Notice: Variation of Permit

Permit Number:	PPC/A/1016719
Site address:	West Cockmuir Strichen Fraserburgh AB42 6RQ
Operator:	Aberdeen & Northern Eggs Limited Company Registration Number: SC098093 Anderson House 9/15 Frithside Street Fraserburgh AB43 5AR
Variation Number:	VAR02
Effective Date of Variation: < <enter date="" dd="" effective="" mm="" yyyy="" –="">></enter>	
Details of Variation:	The permit is varied as specified in the Schedule attached.

1.2.3 Detailed site layout of Auchtygills

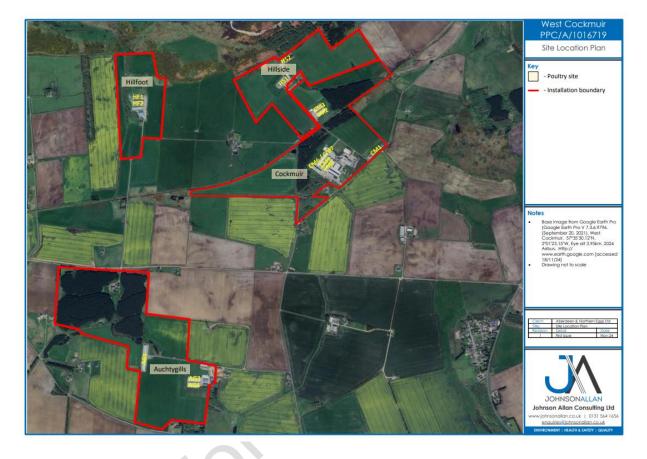
8. 1.2 Location Plan; 1.2.1 West Cockmuir Site Plan; 1.2.2 Hillside Site Plan; 1.2.3 Hillsoot Site Plan and 1.2.4 Auchtygills Site Plan have been deleted and replaced by new Site Plans, as follows:
